To: All SDI Sprayer Dealers
From: Sales Department
Date: May 18, 2012
Subject: Open Orders for SDI Part# 20-0571

**SDI Retro Fit
 Mounting #20-054KIT**

Retro-Mounting Installation Instructions

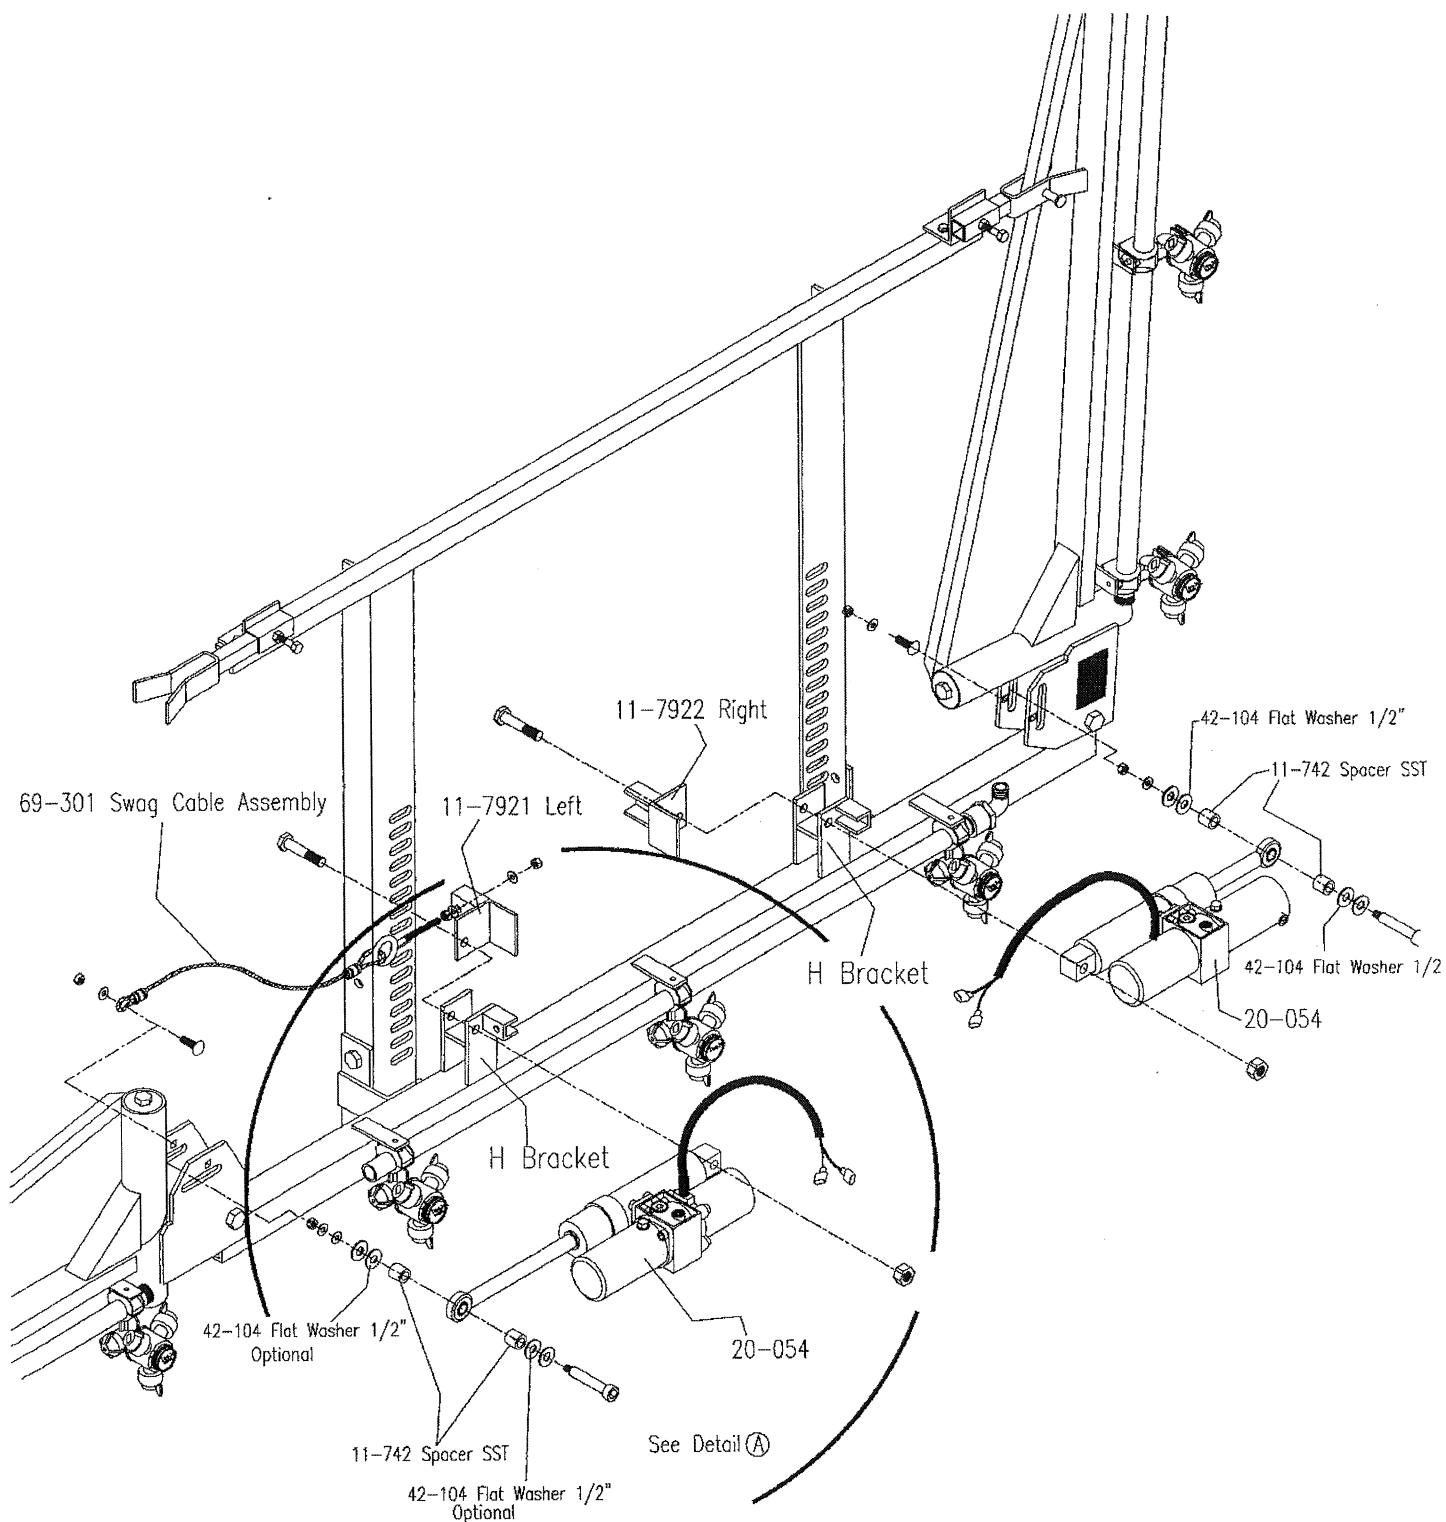
This notice is to inform our dealers with open orders for SDI Part No. 20-0571 that there is an available alternative for the actuators you have on order.

The new 20-054 actuators are a welcome replacement to the older actuators. The new actuators have a sealed hydraulic system that eliminates the clutch and gear system that caused many operational problems on the old units. Because the new units are more robust they cost slightly more, but we are sure you will agree the reduction in operational complaints is well worth the additional cost. These new units are already extensively used in many applications in the turf industry. Those dealers who have purchased the new actuators as replacements report the installation process is straightforward and their customers are pleased with the change.

We have stock on the new 20-054 actuators and can ship all open orders immediately. There is a simple conversion bracket that fits to your existing booms that will allow the new actuators to replace the 20-0571 models. There is no cost for the conversion bracket. We are sending the instructions along with this bulletin to show the replacement process.
The 20-054 conversion can be ordered as follows:

Detail A - Left side of boom
 Top view looking straight down:

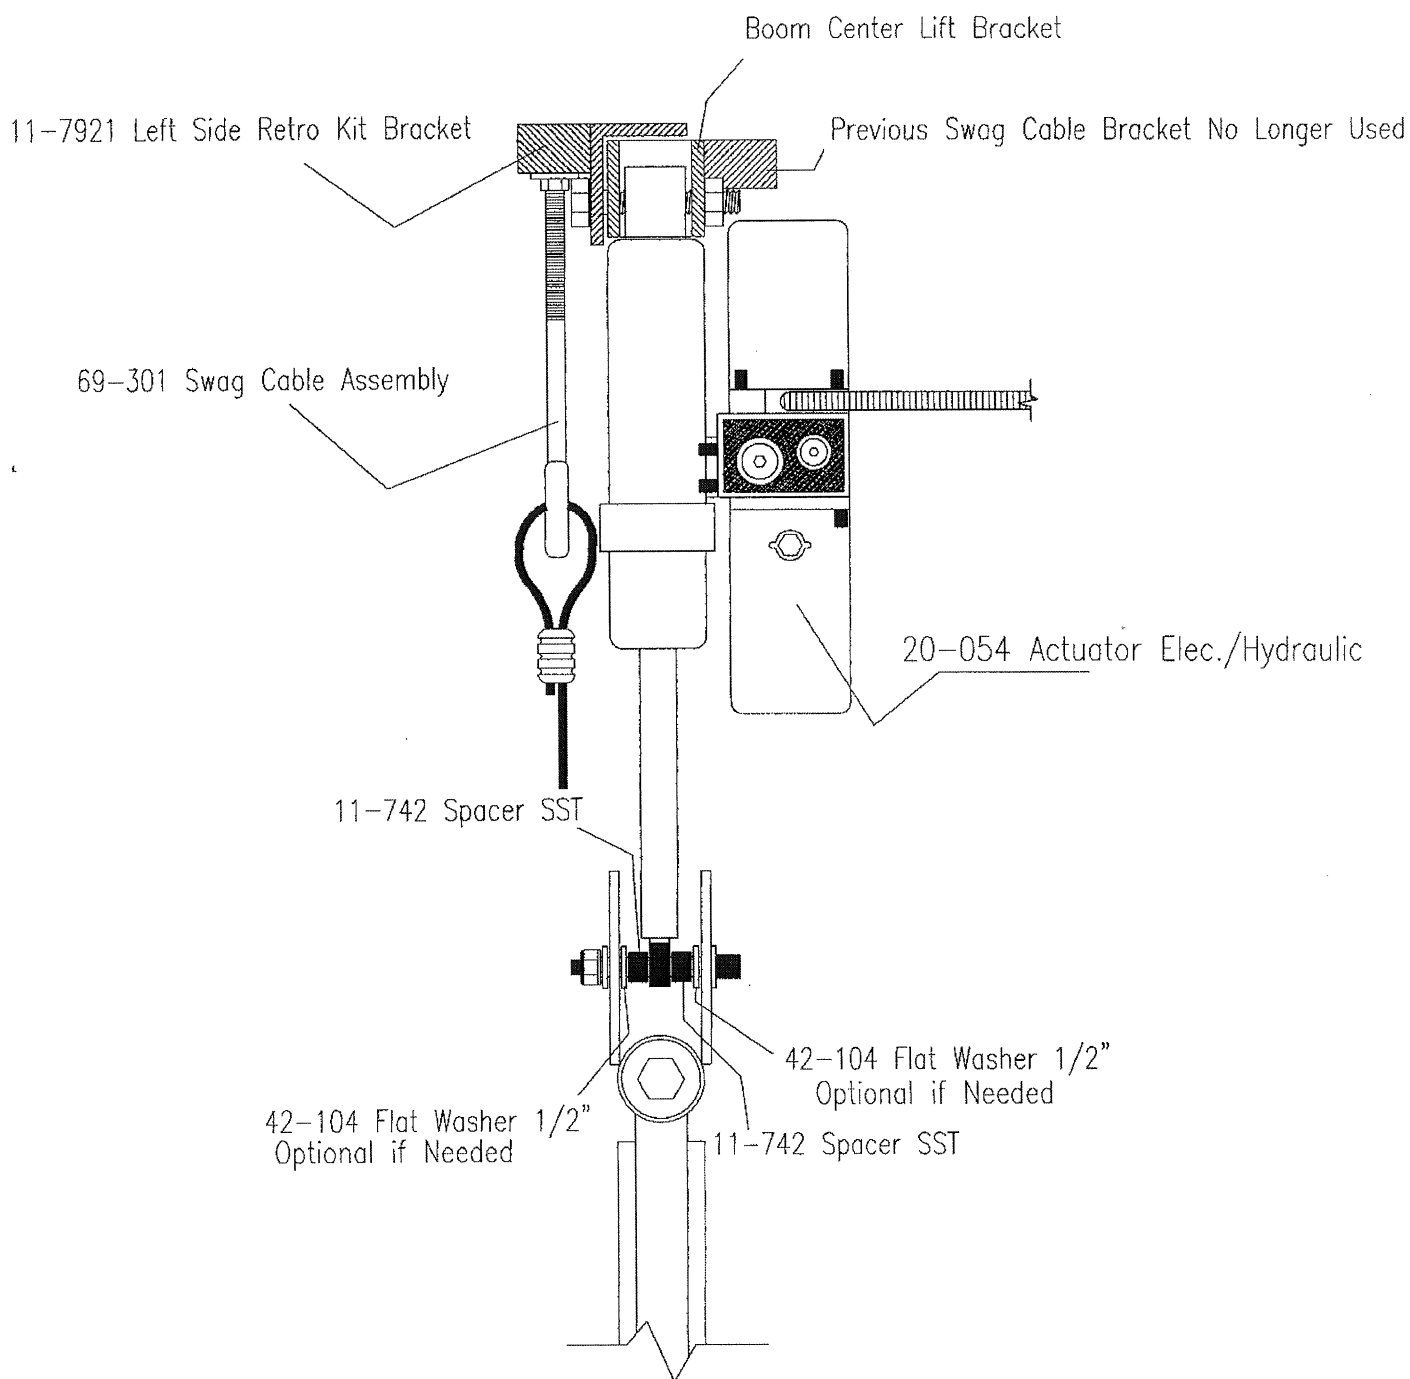
1. Remove nut from pivot bolt on rear of actuator.
2. Install the bracket for the side you are working on (Refer to Detail A on drawing). The bracket should be fairly flush with the top of the H bracket. Reinstall nut on pivot bolt and tighten.
